### ADDENDUM # 3

#### **Bid 19C14, Rock Creek School Replacement Project**

To: All Plan Holders  
Project: Rock Creek School Replacement  
Walkersville, Maryland  
Re: Addendum #3

C-4E

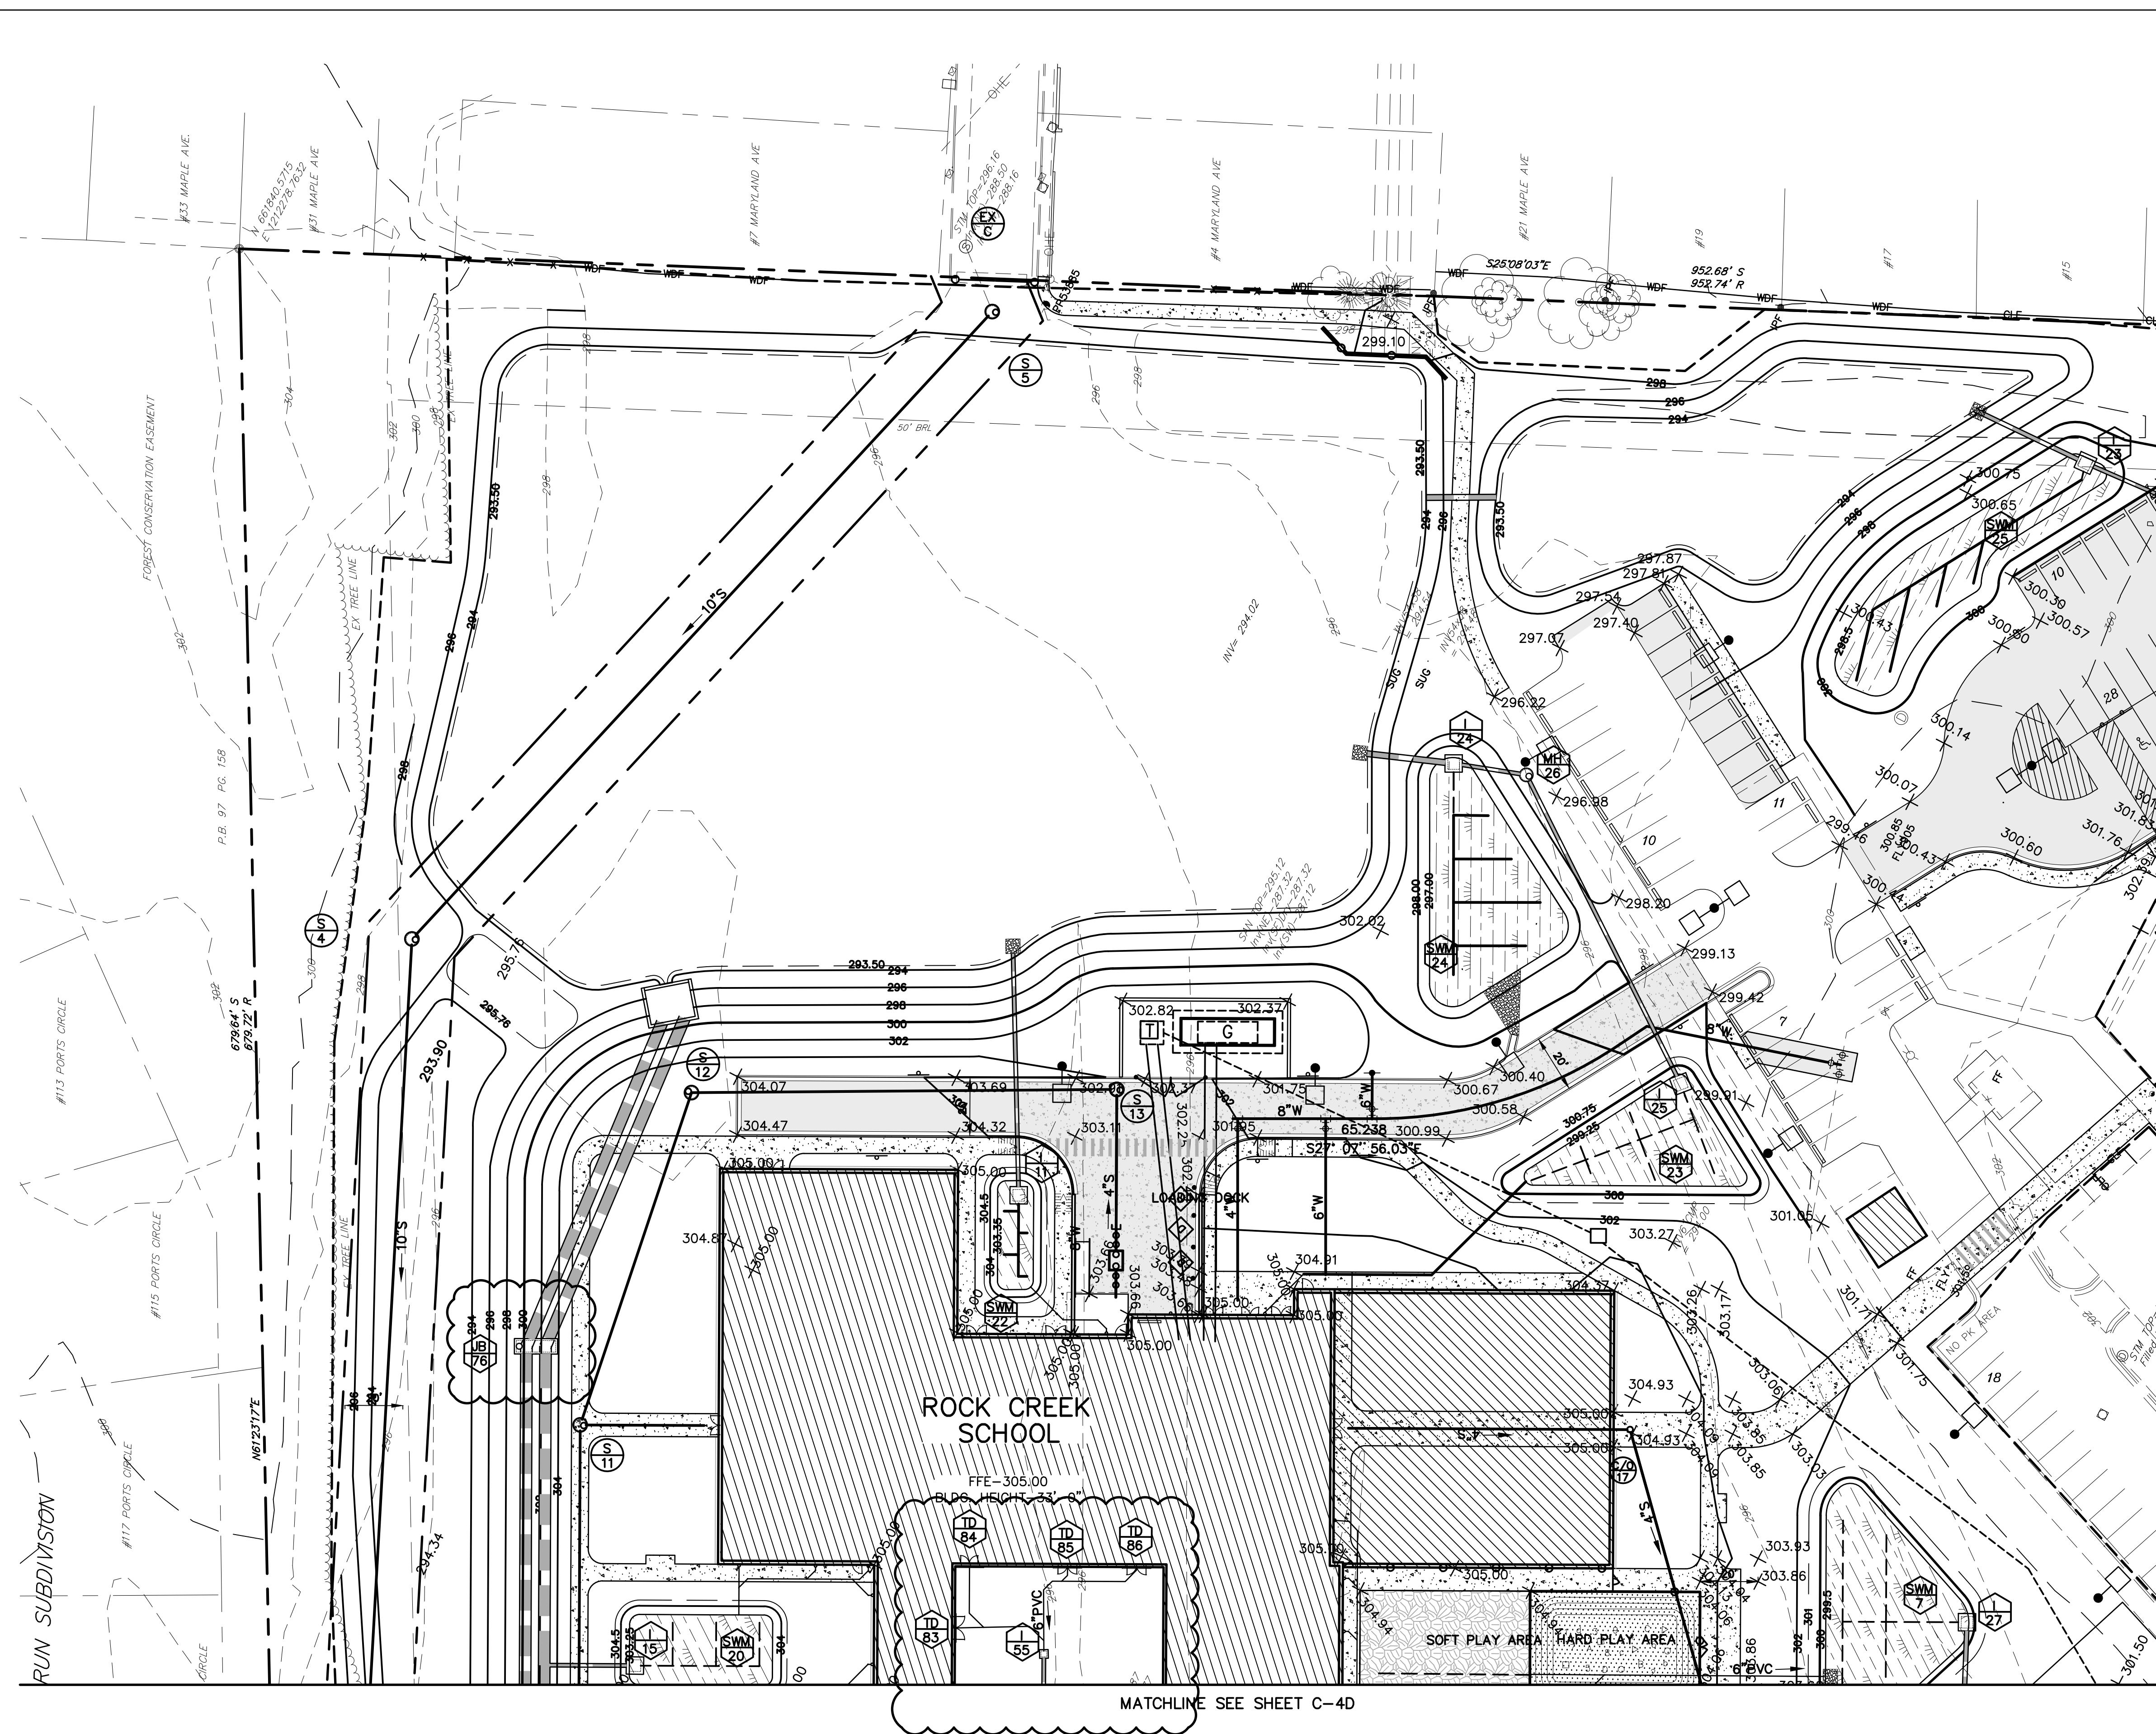
3. **C-4E – GRADING AND STORMWATER MANAGEMENT PLAN**

**REVISE** – Revise courtyard drainage and tie into SWM system.

S101C

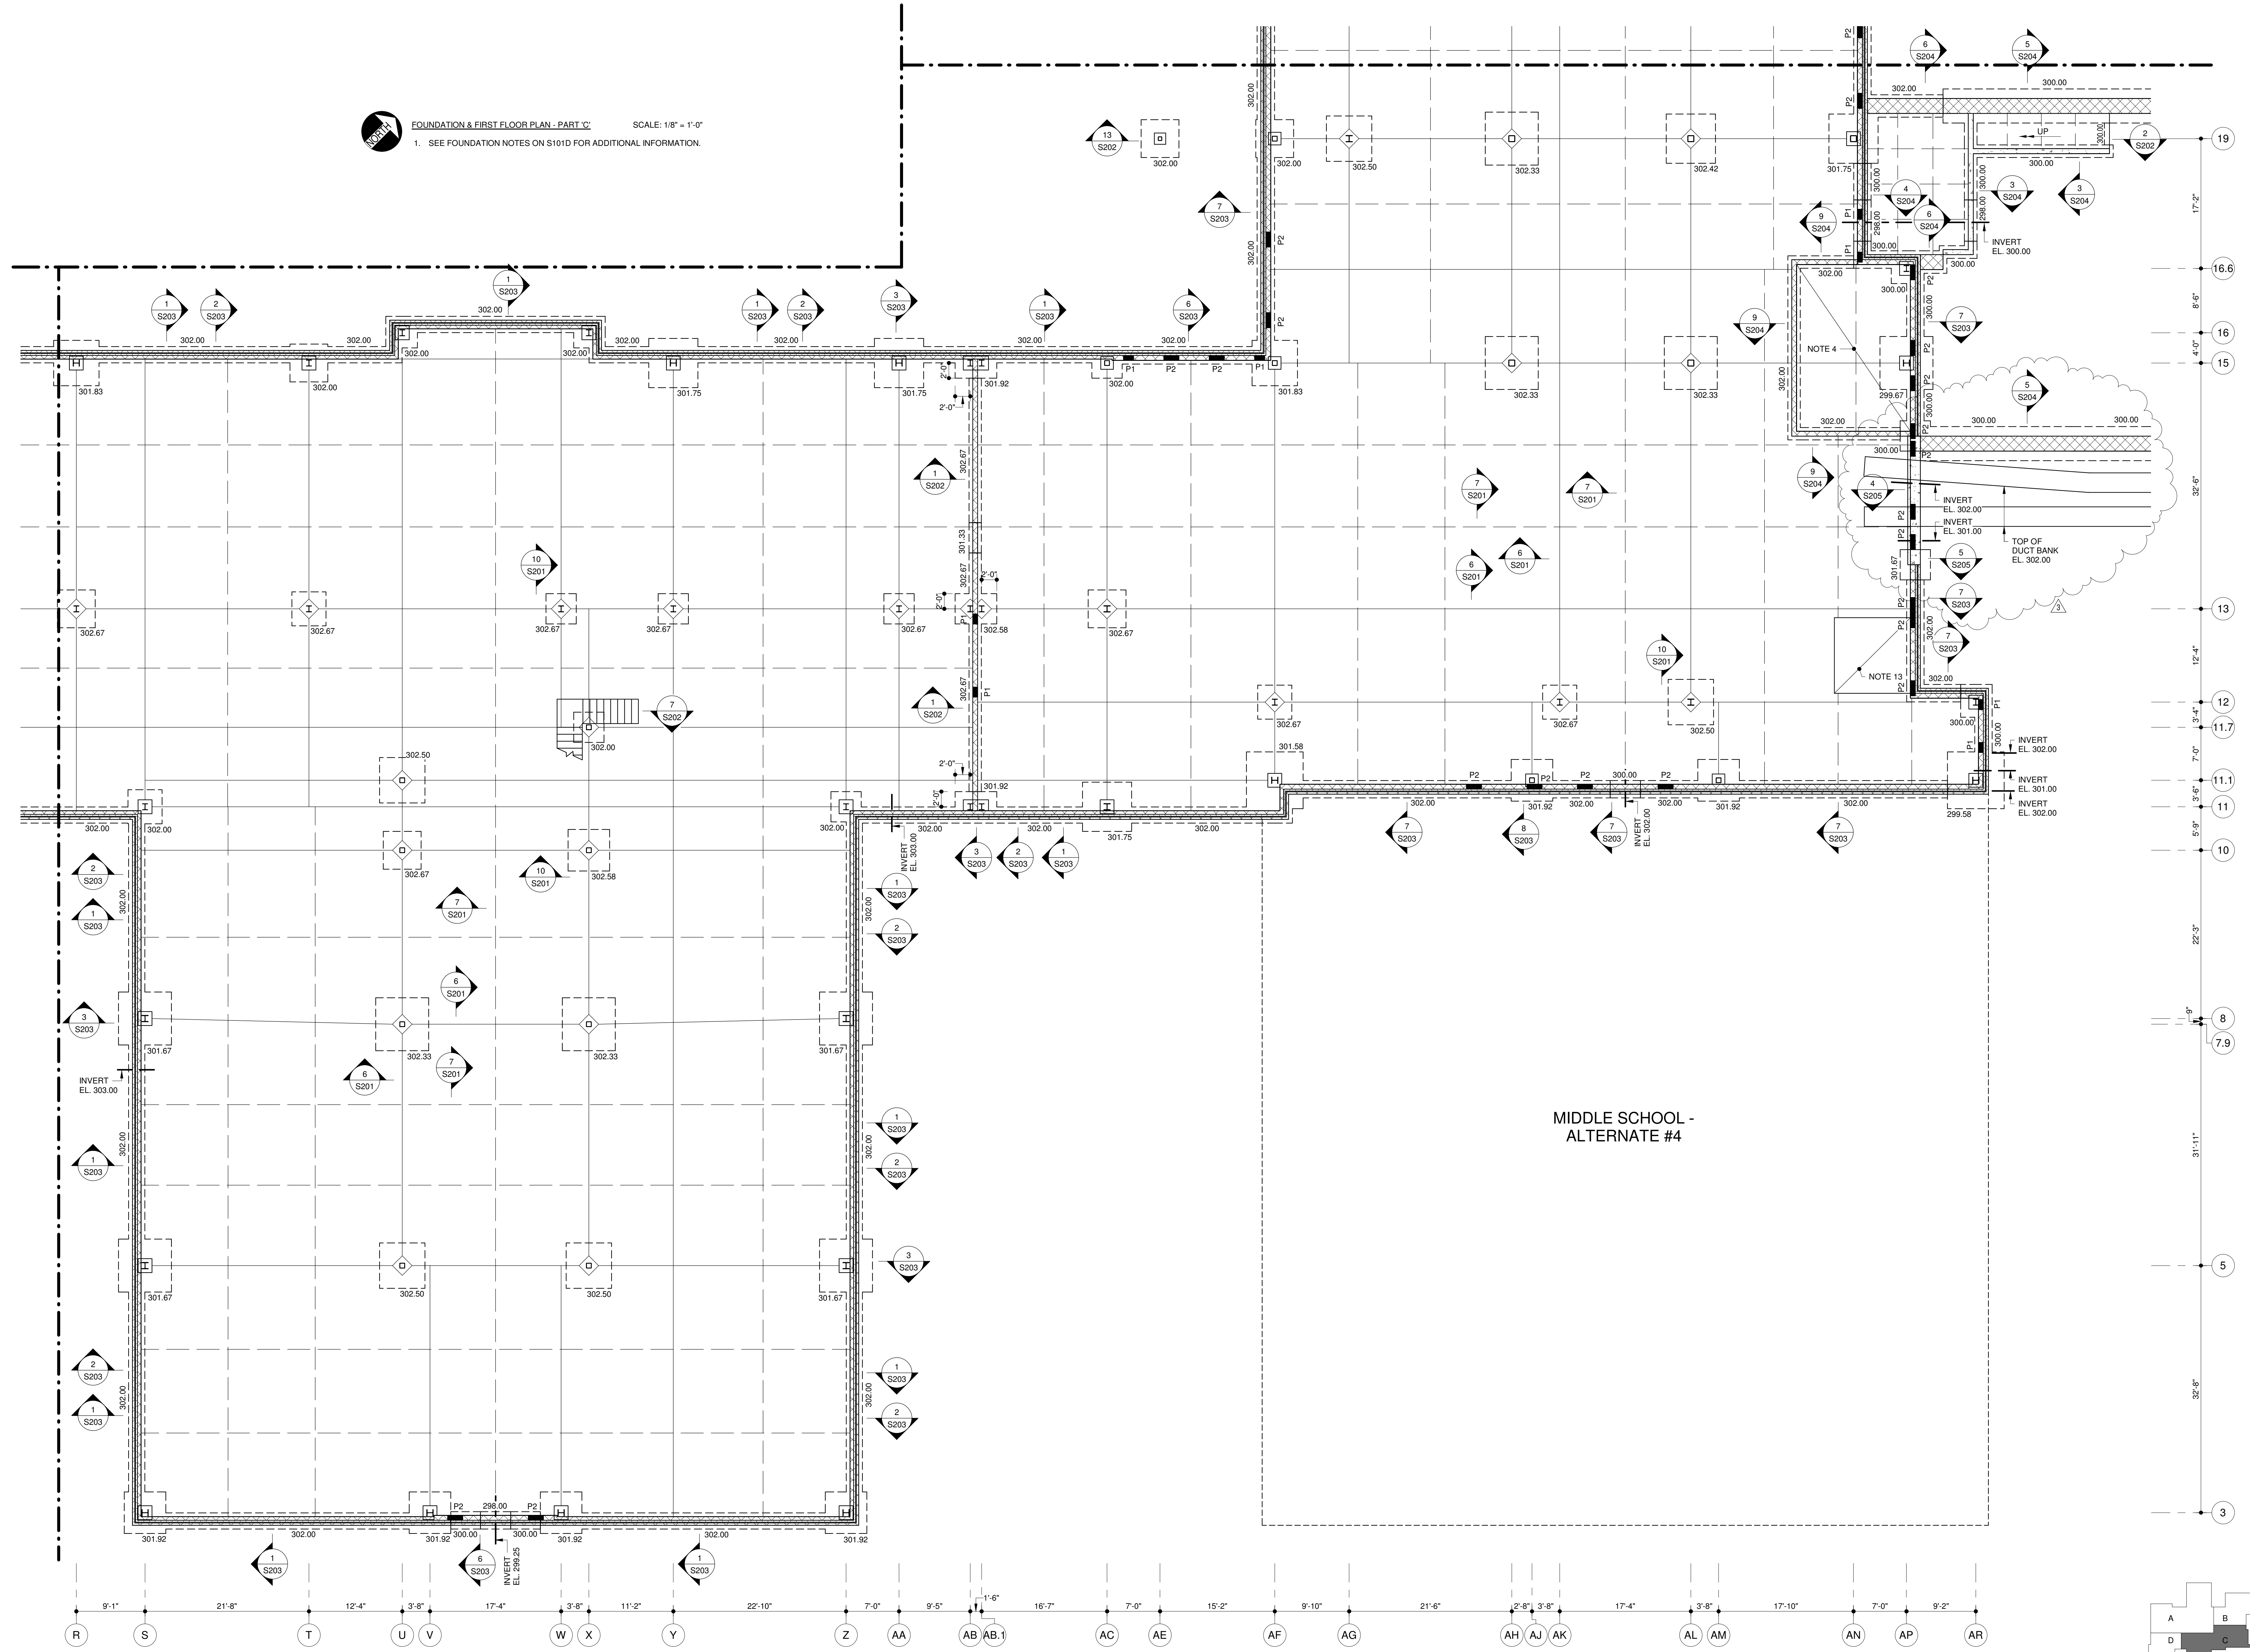
1. **S101C – FOUNDATION AND FIRST FLOOR PLAN – AREA C**

**REVISE – REVISE** footing detail and wall location for incoming duct bank.

M201C

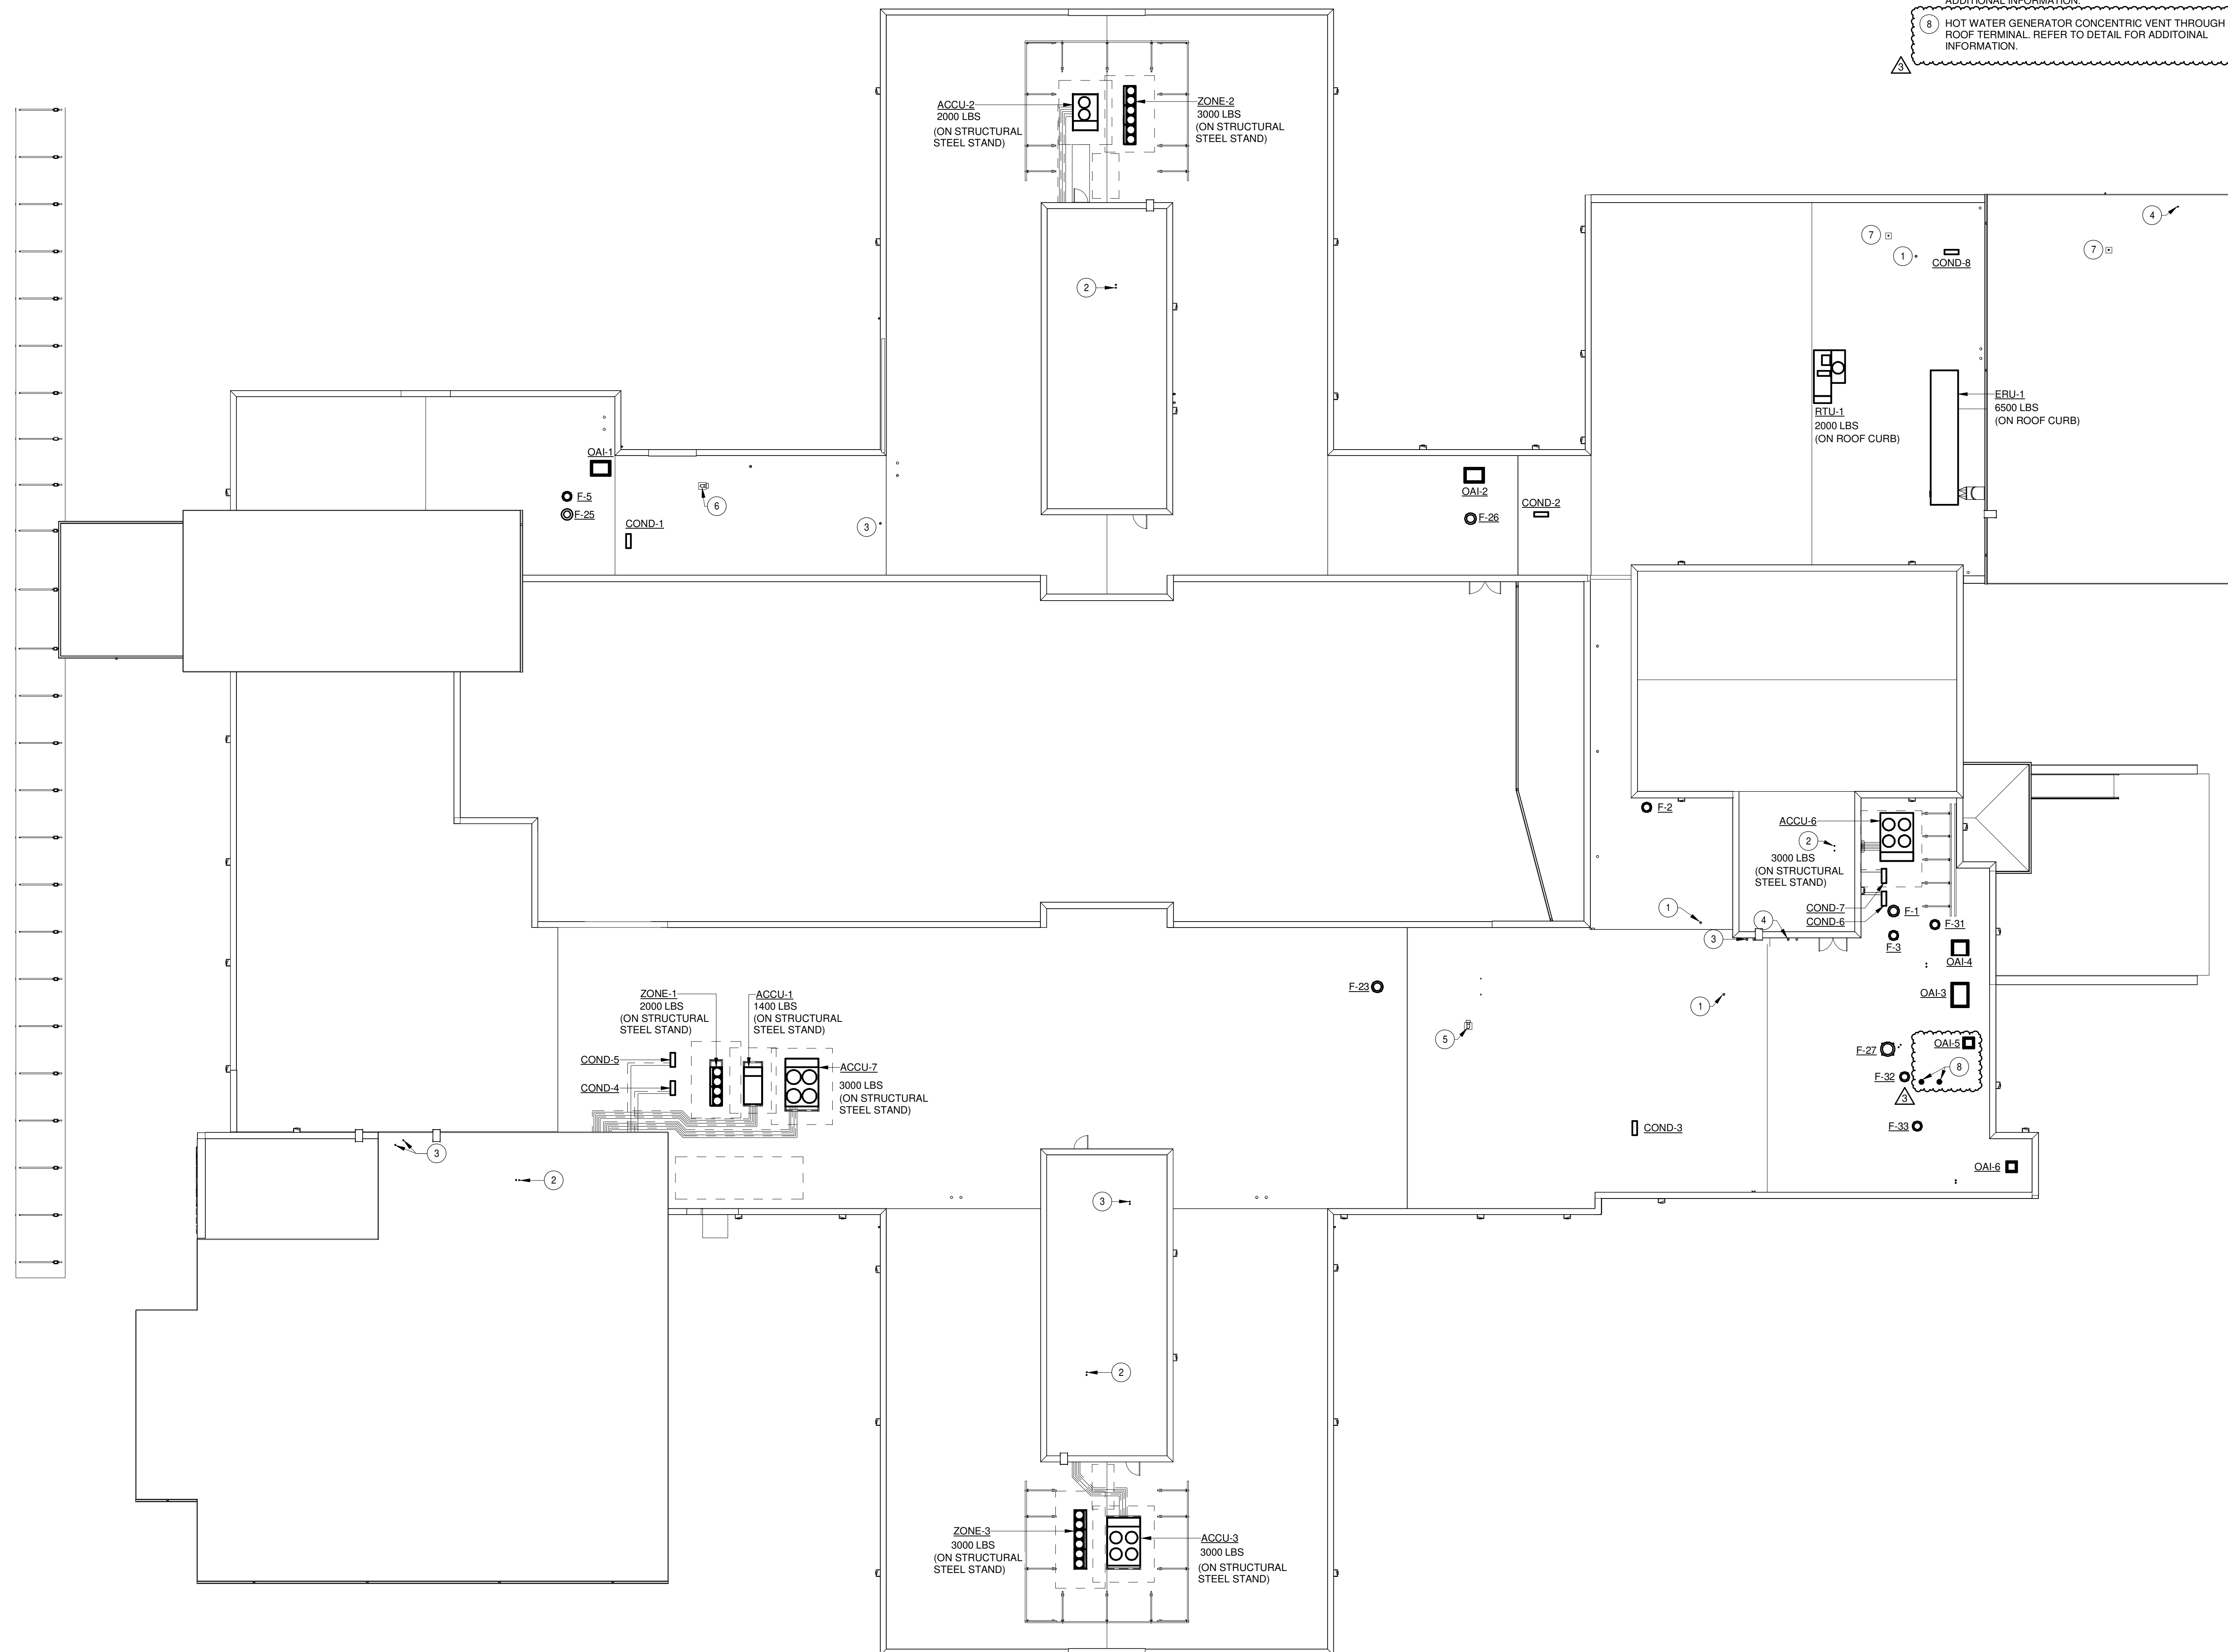
1. **M201C – FIRST FLOOR PLAN – AREA C**

- **ADD** - For domestic hot water generators, combustion air and flue vent ductwork added in Mechanical room 608.
- **ADD** drawing note 53 to read: ***“DOMESTIC HOT WATER GENERATOR. REFER TO PLUMBING DRAWINGS.”***
- **ADD** drawing note 54 to read: ***“4”Ø COMBUSTION AIR DN TO HOT WATER GENERATOR.”***
- **ADD** drawing note 55 to read: ***“4”Ø FLUE VENT DN TO HOT WATER GENERATOR.”***
- **ADD** drawing note 56 to read: ***“4”Ø COMBUSTION AIR AND FLUE VENT UP TO CONCENTRIC VENT THROUGH ROOF TERMINAL. REFER TO DETAIL FOR ADDITIONAL INFORMATION.”***
- **REVISE** - Location of **OAI-5** and associated appurtenances revised to provide clearance from hot water generator flue.
